# Intel<sup>®</sup> i960<sup>®</sup> RM/RN/RS I/O Processor

*Specification Update*

*September 4, 2001*

Order Number: [273164-020](#)

**7. Data Corruption Occurs when Transfer Data Value Matches the Memory Mapped Register (MMR) Addresses of the DMA Channels**

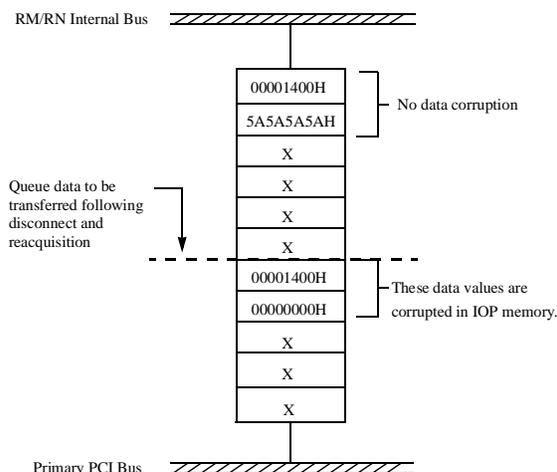
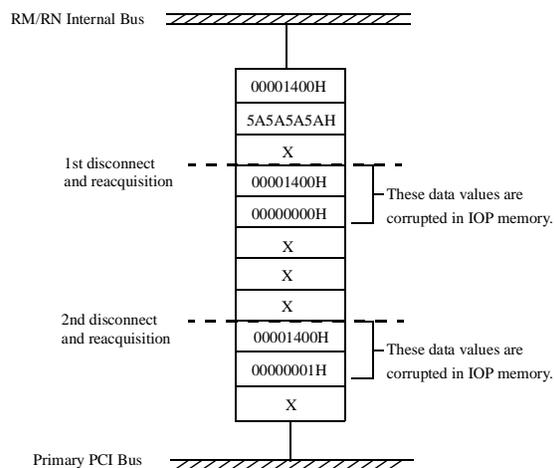
**Problem:** This problem appears across all 3 DMA channels: DMA Ch-0, Ch-1, and Ch-2. If the transfer data value falls within the MMR address range of the active DMA channel (1400H - 143FH for Ch-0, 1440H - 147FH for Ch-1, and 1480H - 14FFH for Ch-2), data corruption will occur.

Examples on [page 19](#) describe the error condition.

**Implication:** Data corruption results when the data value matches the MMR address range of the active DMA channel.

**Workaround:** There are two possible workarounds for this errata:

- Use the Primary Address Translation Unit (PATU) to transfer data from Primary PCI to IOP memory and Secondary Address Translation Unit (SATU) to transfer data from Secondary PCI to IOP memory.
- Configure the Memory Controller Unit to execute in 32-bit mode. For further information, refer to Section 13.3.3 on page 13-14 of the *i960<sup>®</sup> RM/RN I/O Processor Developer's Manual* and to Table 4 in the 80960RM/RN I/O processor datasheets.

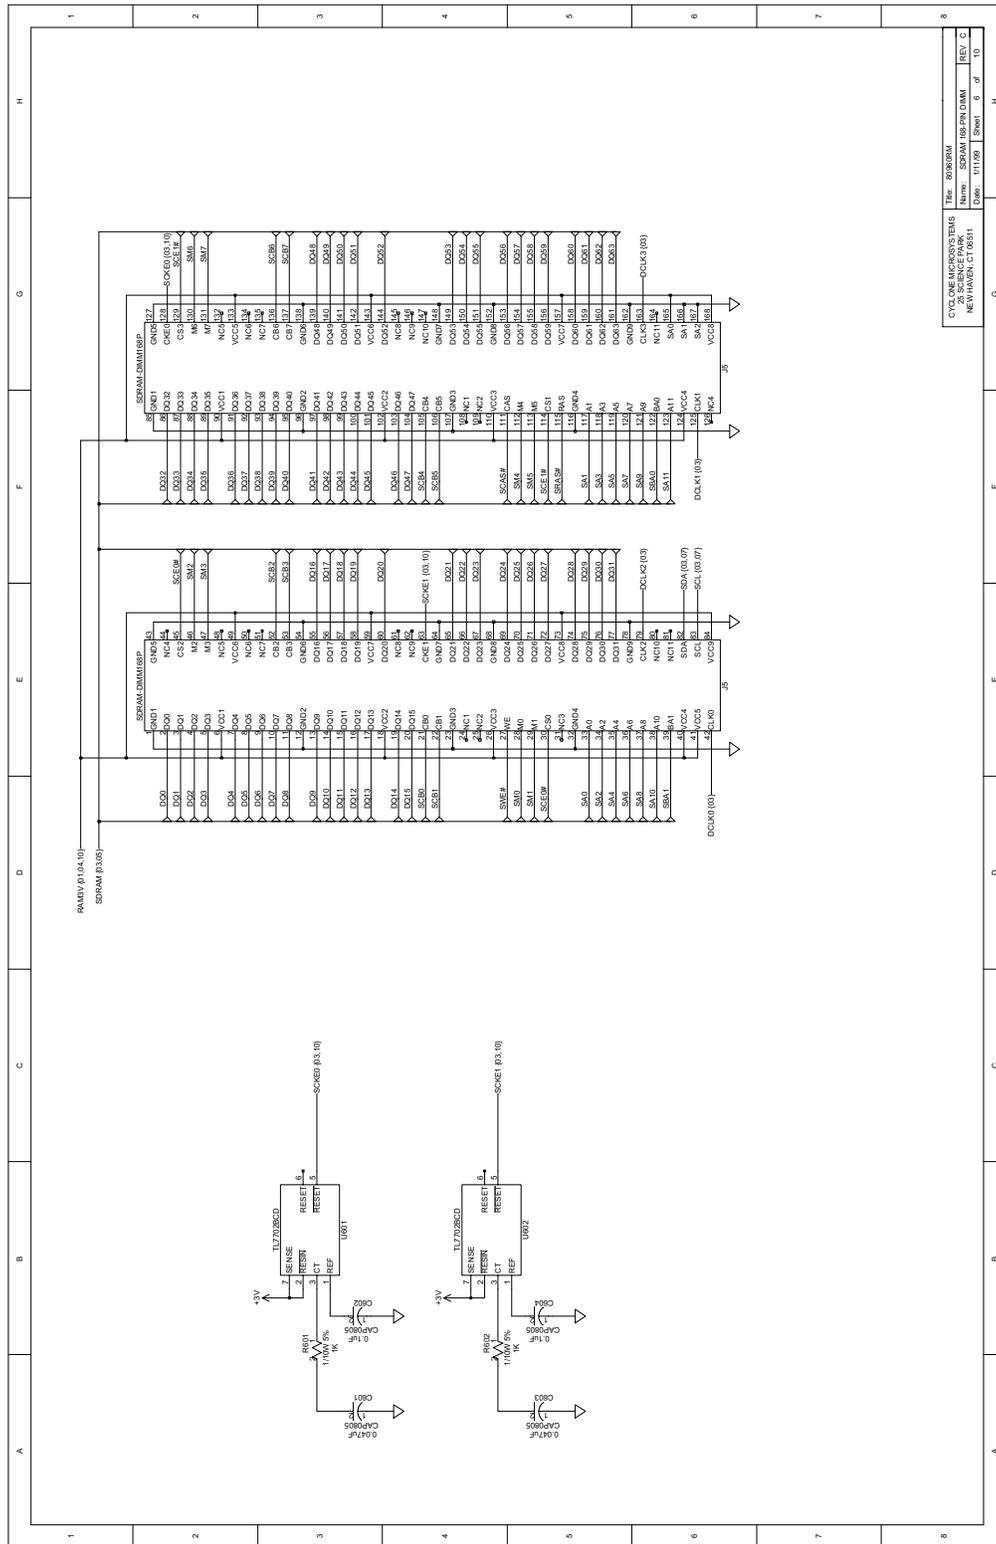
**Problem:** During the power-up reset sequence, as the RM/RN supply voltage ramps to 3.3 Volts, a glitch occurs on the Clock Enable pins (SCKE) to the SDRAM at around 2 Volts. Occasionally this causes the SDRAM to enter a pseudo, self-refresh mode which causes a lock-up condition on the SDRAM device. The only way to clear this condition is to power-down the SDRAM. The SDRAM initialization sequence will not clear the lock-up condition.

**Workaround:** Tie the Clock Enable Inputs on the SDRAM DIMM to  $V_{CC}$ .

## 2. Hooking up the SDRAM Clock Enable Outputs (SCKE0 and SCKE1) from the i960® RM/RN I/O Processor to the Clock Enable Inputs on the SDRAM DIMM in a Battery-Backup Application

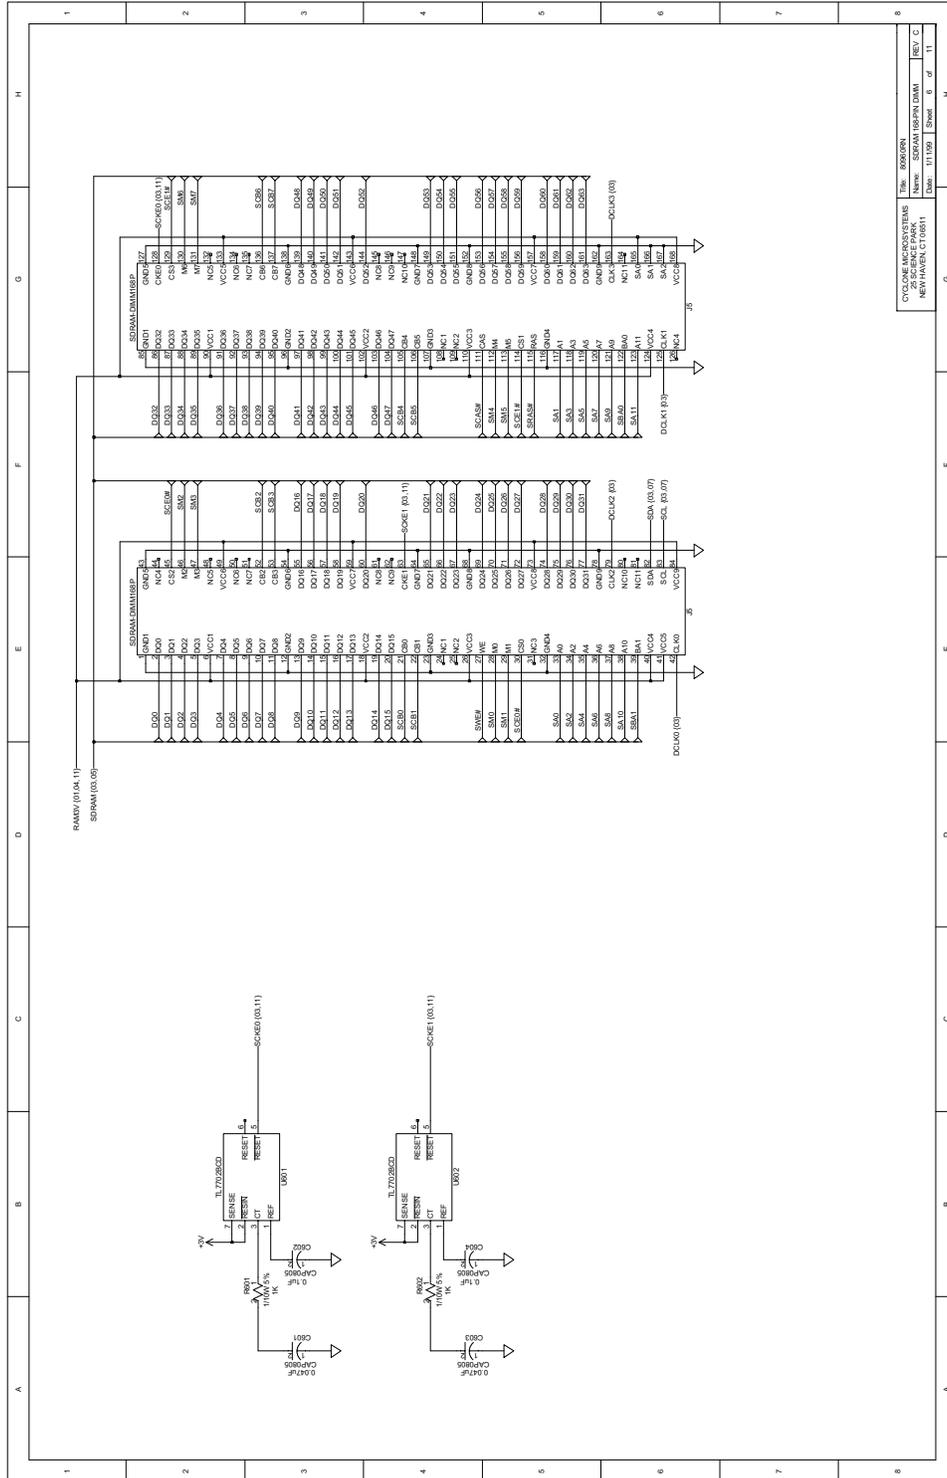
**Problem:** During the power-up reset sequence, as the RM/RN supply voltage ramps to 3.3 Volts, a glitch occurs on the Clock Enable pins (SCKE) to the SDRAM at around 2 Volts. Occasionally this causes the SDRAM to enter a pseudo, self-refresh mode which causes a lock-up condition on the SDRAM device. The only way to clear this condition is to power-down the SDRAM. The SDRAM initialization sequence will not clear the lock-up condition.

**Workaround:** Ensure that the Clock Enable Inputs to the SDRAM DIMM are held low during power-up. An example workaround is shown in the following circuit schematics and was tested on the i960RM/RN evaluation boards (Sheet 6 – 80960RM schematics and Sheet 6 – 80960RN schematics in *i960® RM/RN I/O Processor Design Guide*).

**Figure 15-2. ATU Queue Architecture Block Diagram**

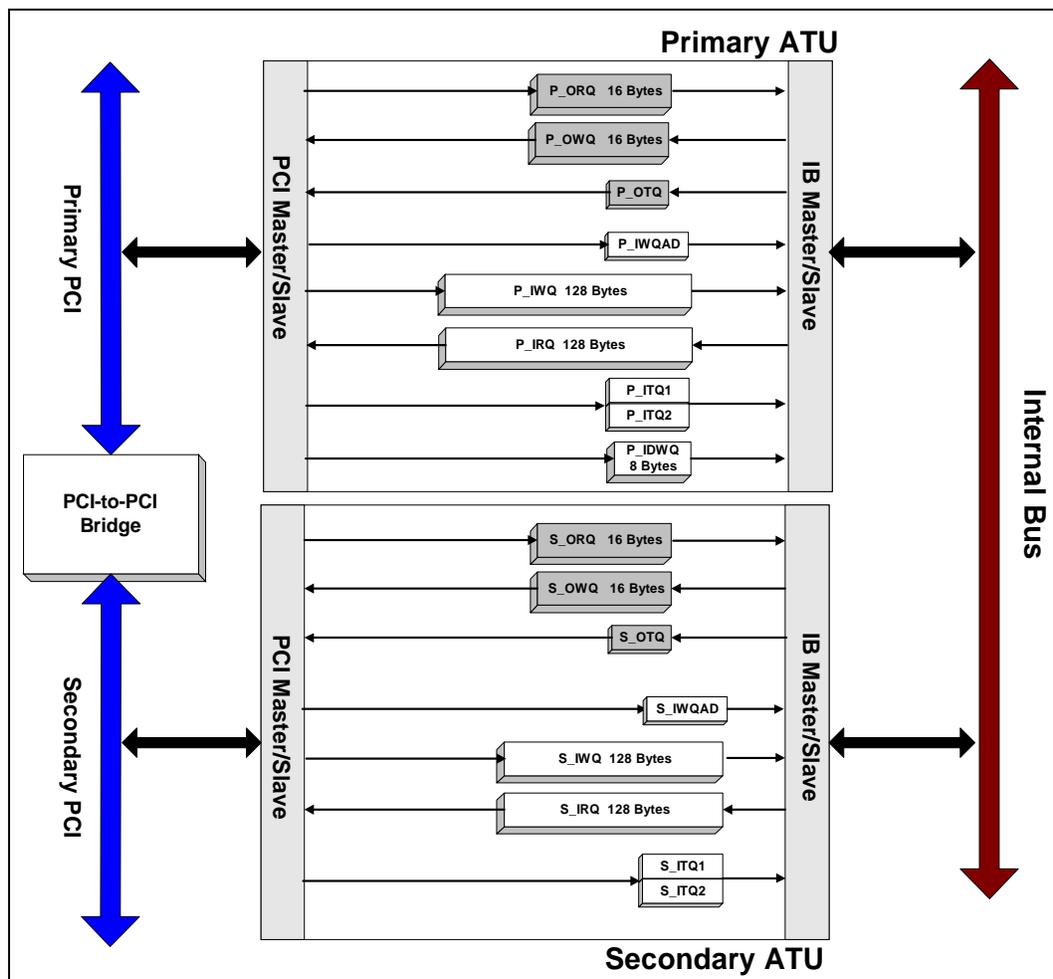
**5. Section 15.1 of the i960® RM/RN I/O Processor Developer’s Manual**

**Issue:** Figure 15-2 on page 15-3 has been changed. The arrows in the box containing P\_IRQ 128 Bytes have been reversed. See Figure 15-2.

**17. Section 14.15.22 in the i960<sup>®</sup> RM/RN I/O Processor Developer's Manual**

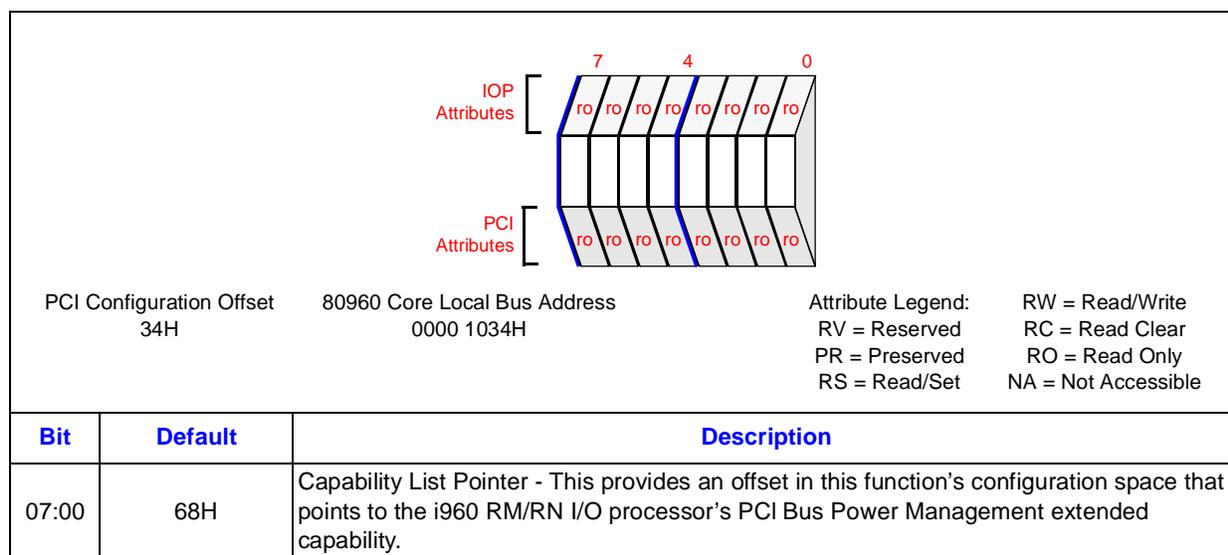
**Issue:** The Bridge Subsystem ID Register (BSIR) has been removed in the RM/RN B-0 stepping. This field is optional according to the *PCI Local Bus Specification* Revision 2.2.

A7695-01

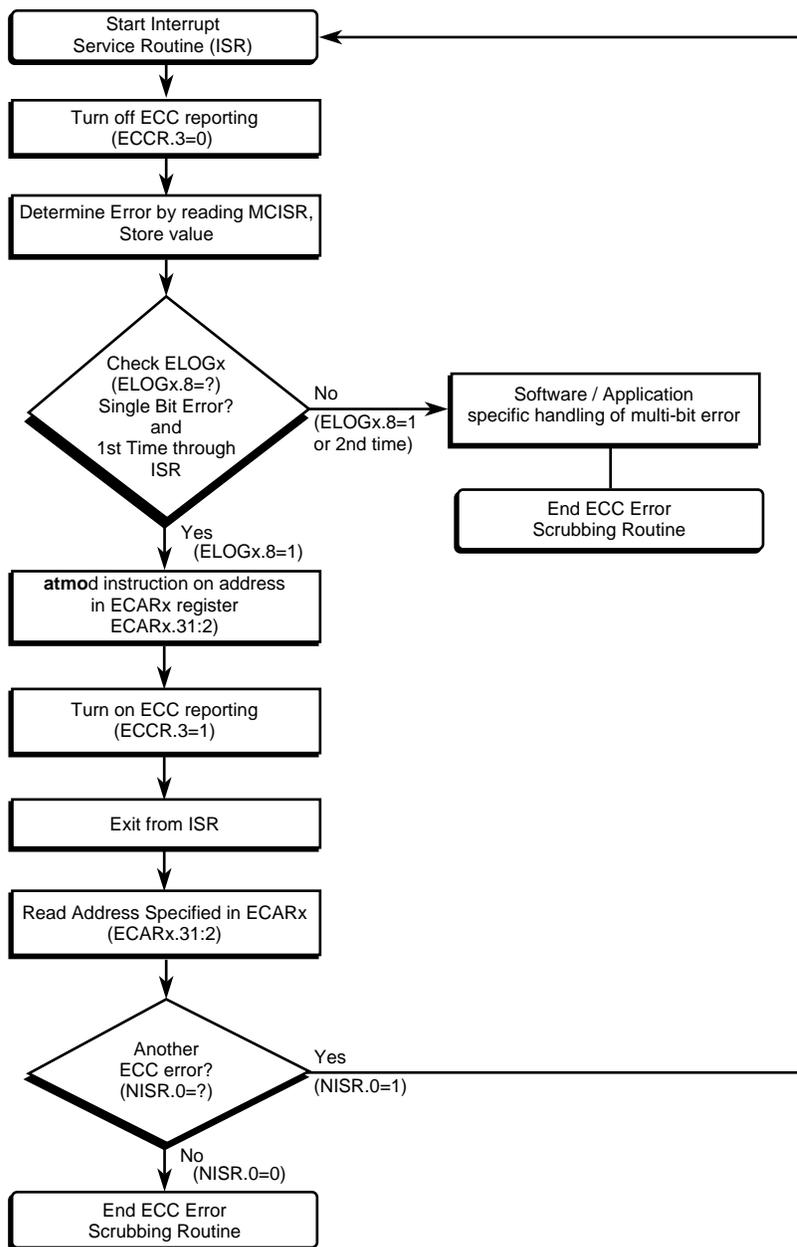
9. If another error is generated, treat this as a multi-bit error.

The diagram below is a flowchart version of the scrubbing routine.
